Subject: Revello Drive & Tramonto Drive Residential Project Traffic & Transportation Evaluation Peer Review, City of Los Angeles, California

MAT Engineering, Inc. (Consultant) has conducted a peer review of the transportation/traffic-related analysis and evaluation for the Revello Drive & Tramonto Drive Residential Project and provides the following comments.

Attachment A Field Photos

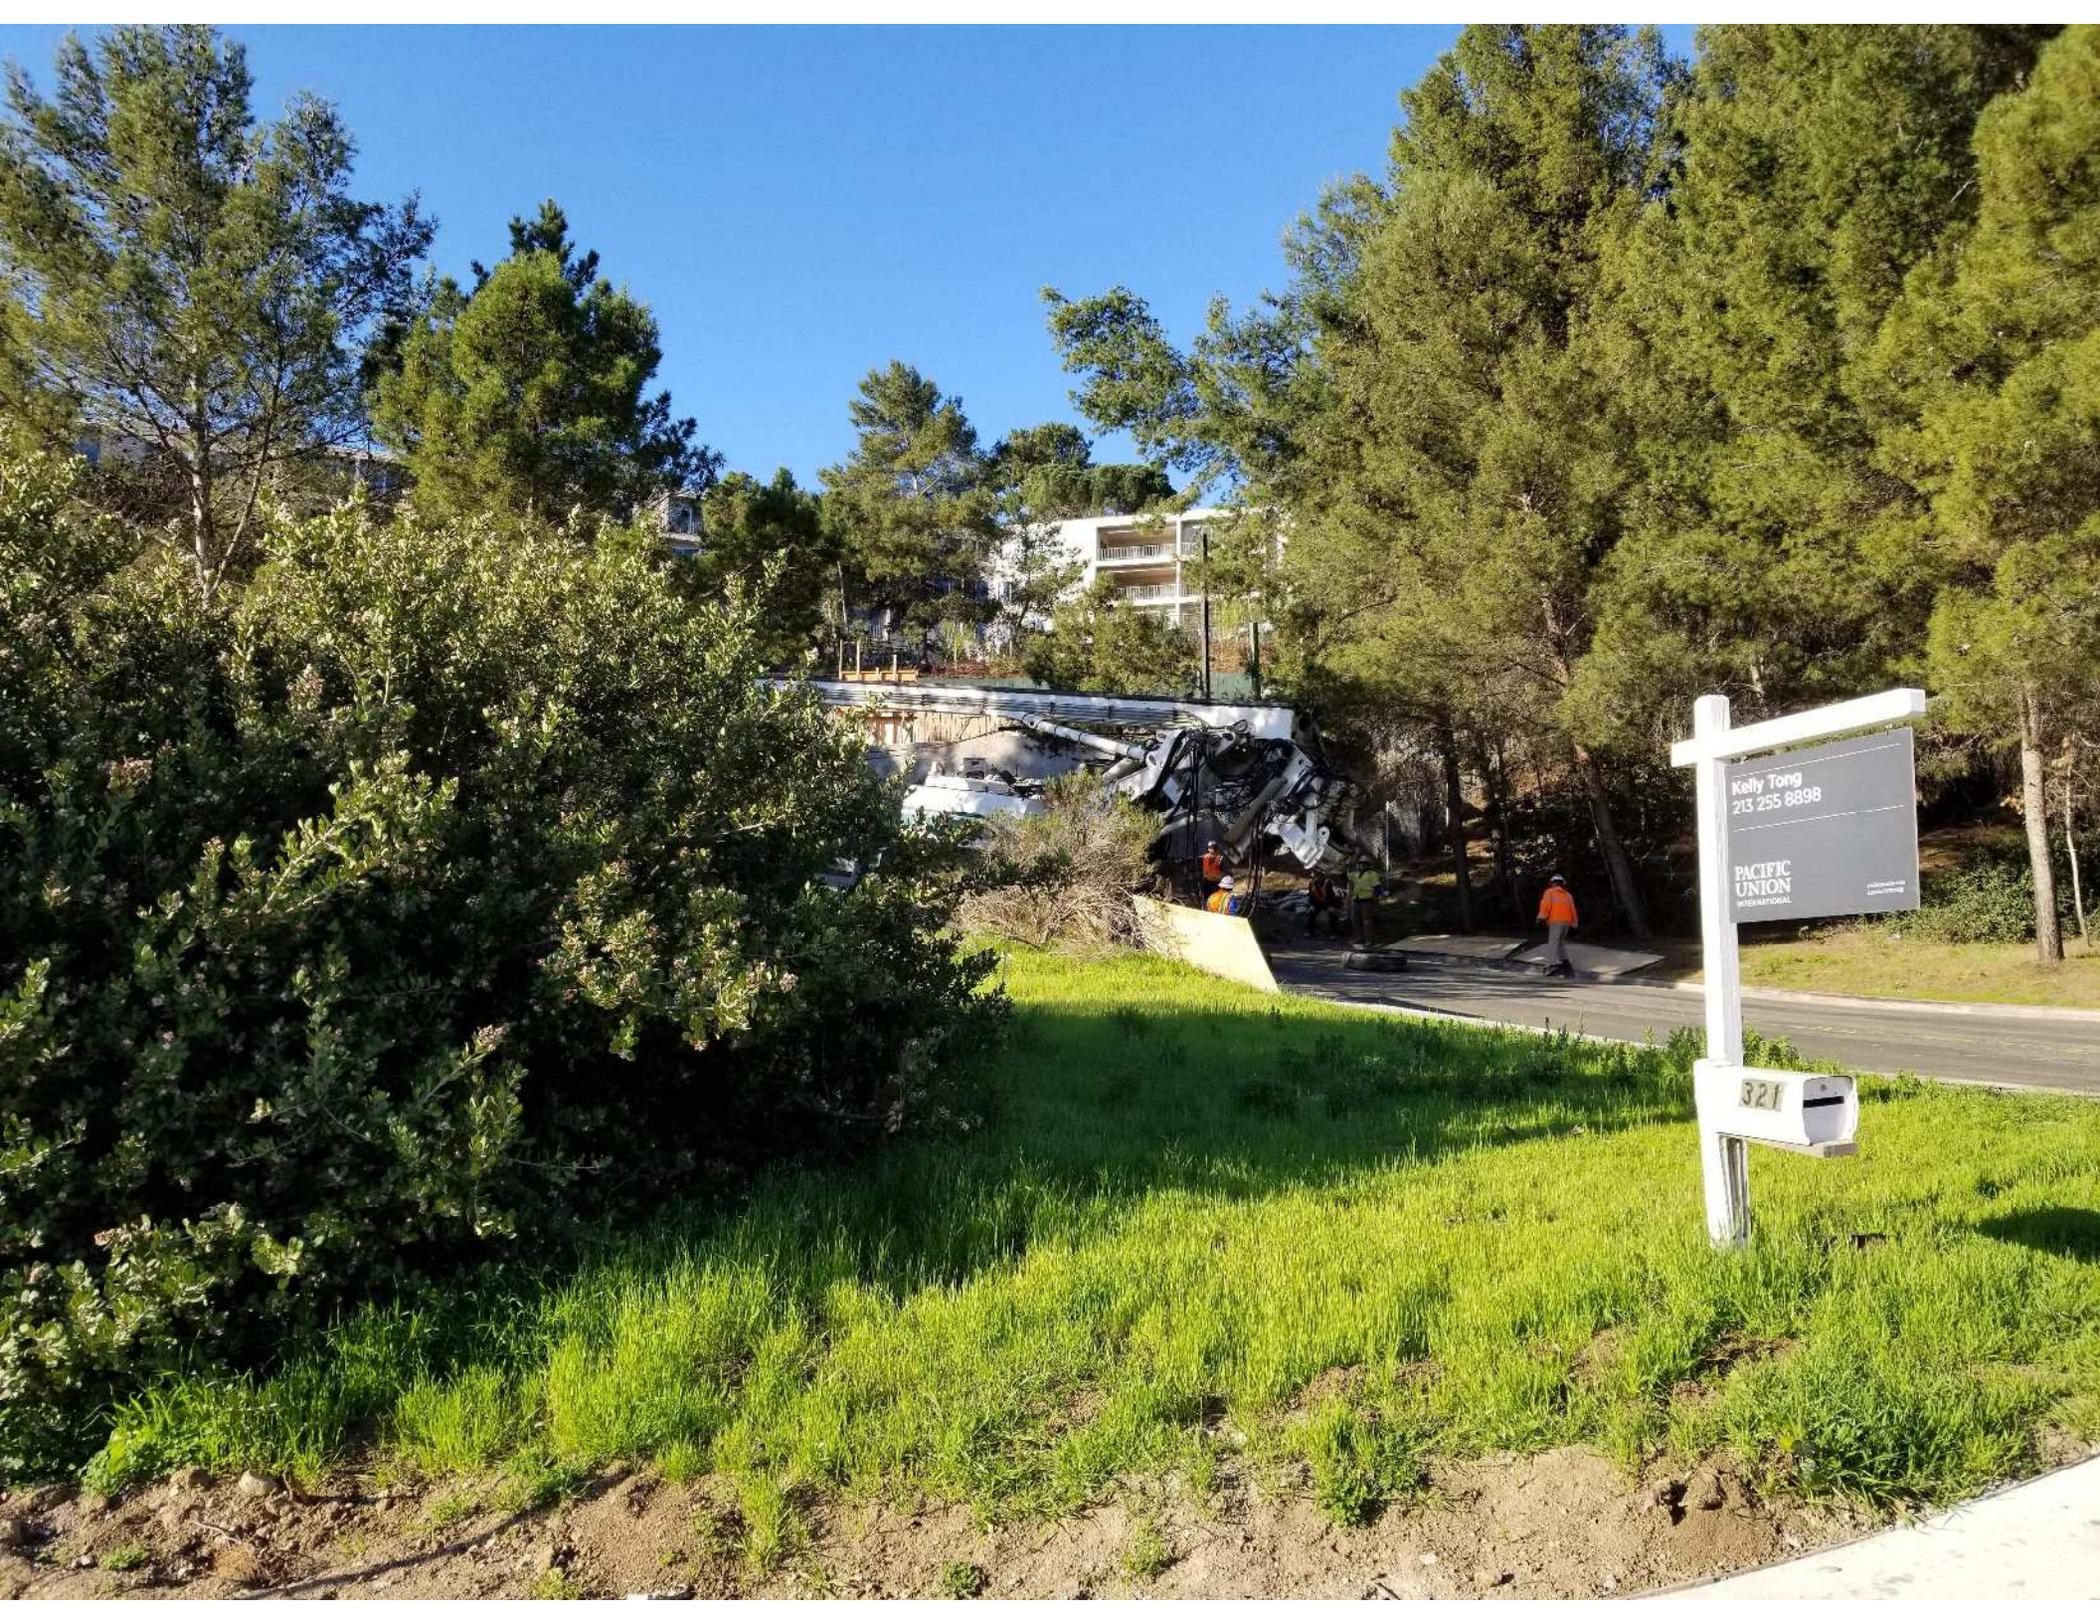
Attachment A shows field photos of the narrow roadways and circulation system being blocked and further constricted by other construction projects and equipment in the area as well as congestion observed on the roadway system. These serve as examples of how even smaller projects have been able to impede traffic flow in the area.
